2.4 Revised Scheme

2.5 Permitted NMA Scheme

AX_(00)_1221

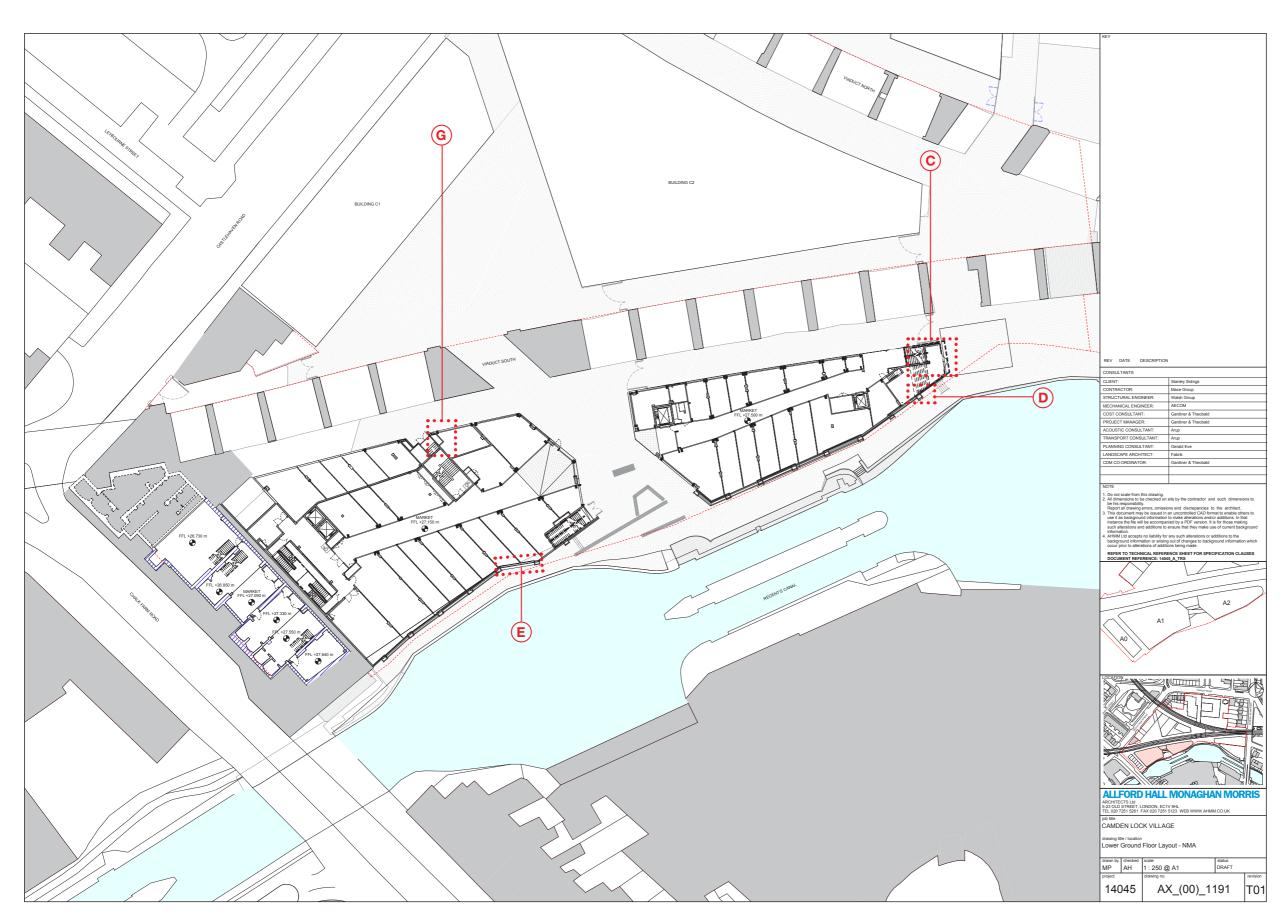
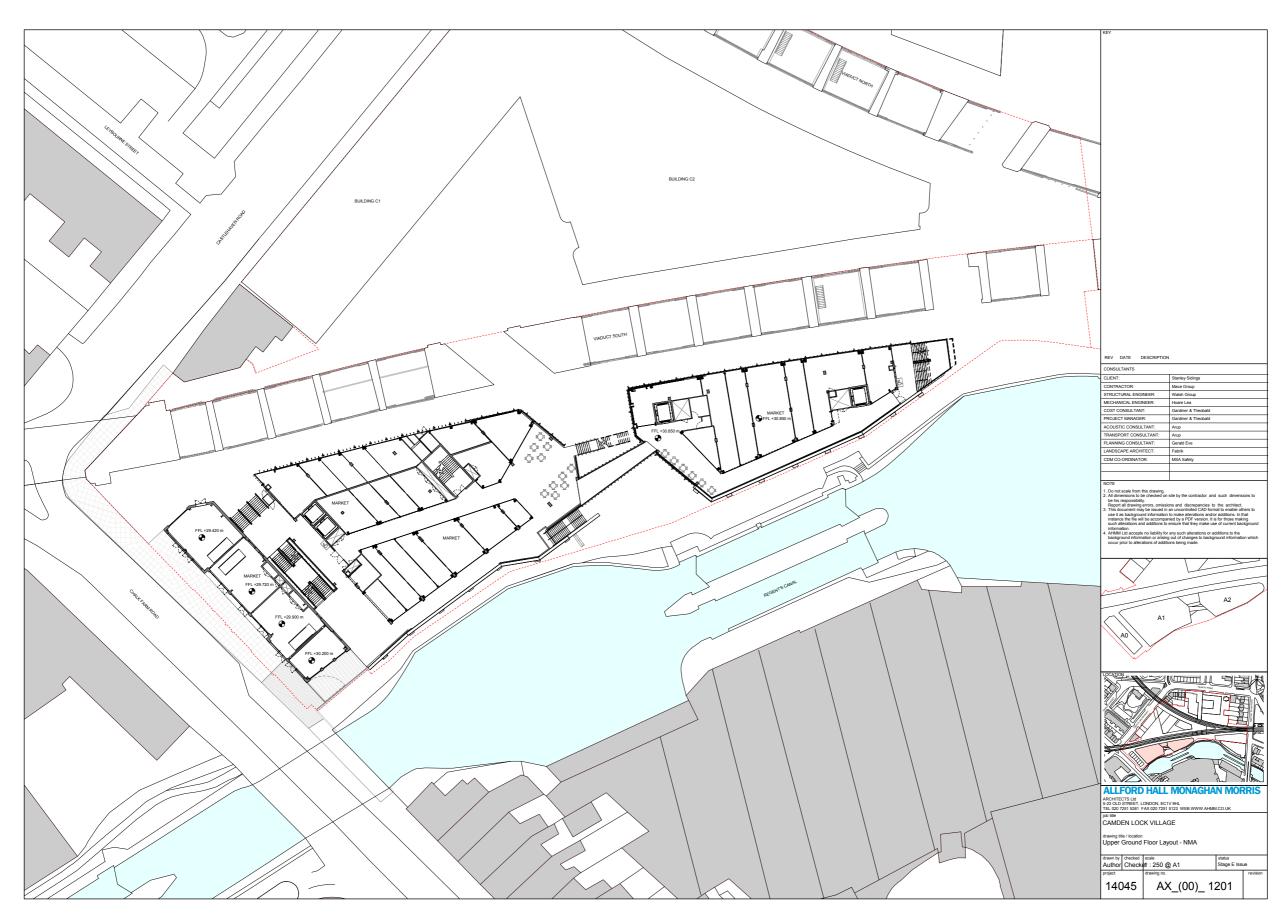
- Rooftop Plant no longer requires chimneys
- B Omission of external shutters on second floor refer to 2.13-2.23.
- UKPN room enclosure to be louvred on east and north elevations
- UKPN room requires louvres on south elevation
- E Canal Wall Window included in previous NMA relocated
- F Solidity of north facade increased on third floor restaurants, where plant and kitchens are expected to be located.
- G Ventilation shaft relocated adjacent to core 02
- Additional fixed window (shown as door in previous NMA)

2.6 Revised Scheme

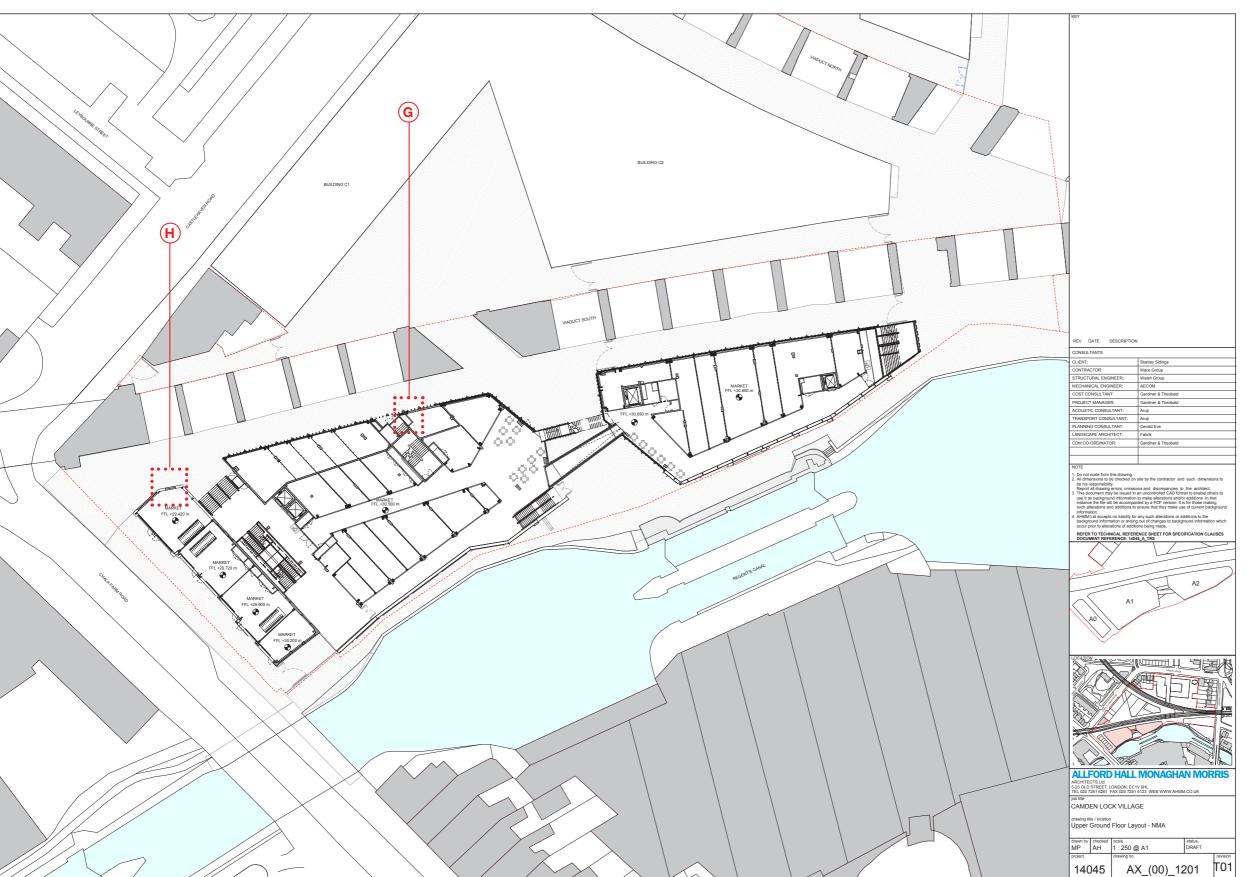
Revisions Rooftop Plant no longer requires chimneys B Omission of external shutters on second floor - refer to 2.13-2.23. C UKPN room enclosure to be louvred on east and north

elevations

- UKPN room requires louvres on south elevation
- E Canal Wall Window included in previous NMA relocated
- F Solidity of north facade increased on third floor restaurants, where plant and kitchens are expected to be located.
- G Ventilation shaft relocated adjacent to core 02
- Additional fixed window (shown as door in previous NMA)

2.8 Revised Scheme

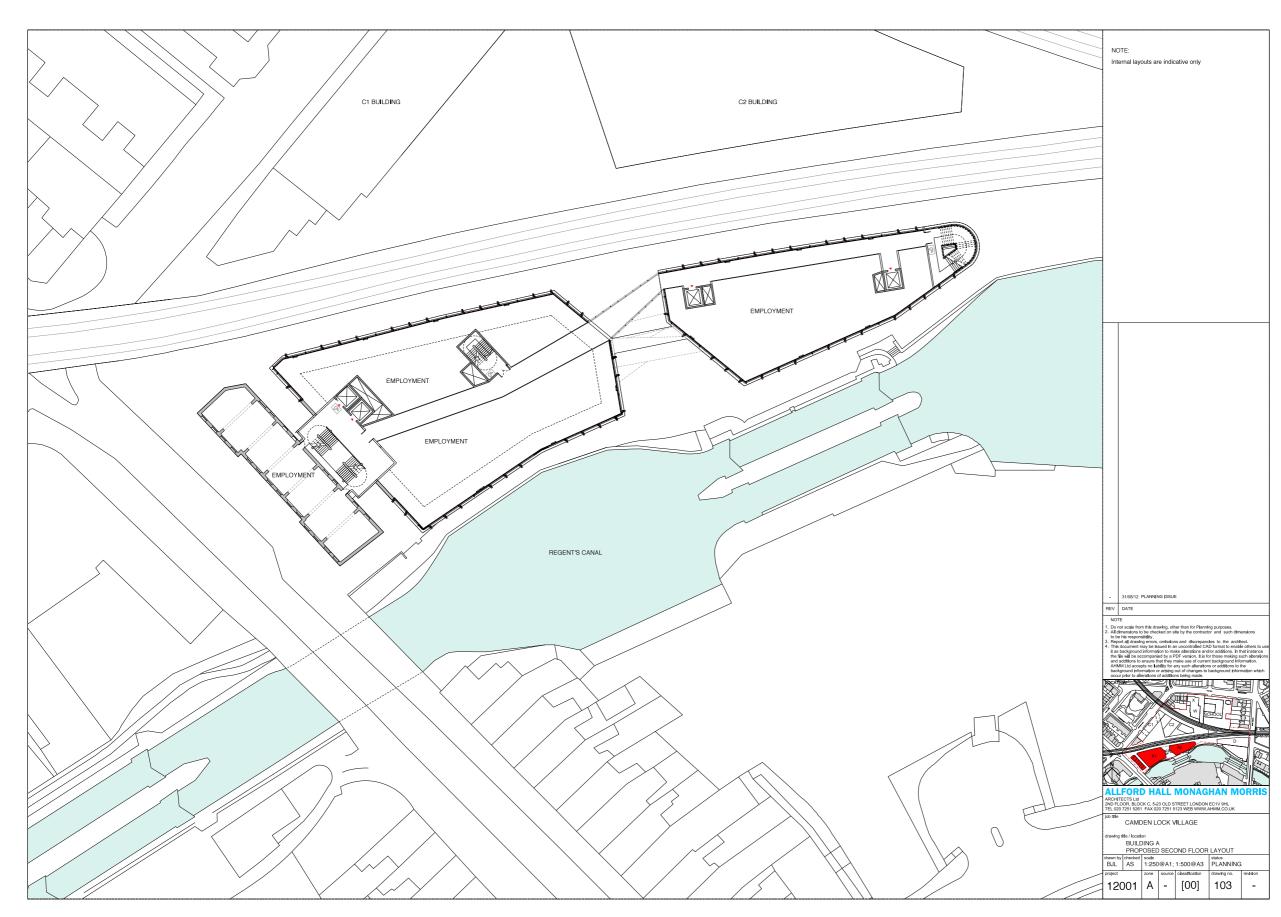
- Rooftop Plant no longer requires chimneys
- B Omission of external shutters on second floor refer to 2.13-2.23.
- UKPN room enclosure to be louvred on east and north elevations
- UKPN room requires louvres on south elevation
- E Canal Wall Window included in previous NMA relocated
- F Solidity of north facade increased on third floor restaurants, where plant and kitchens are expected to be located.
- G Ventilation shaft relocated adjacent to core 02
- Additional fixed window (shown as door in previous NMA)
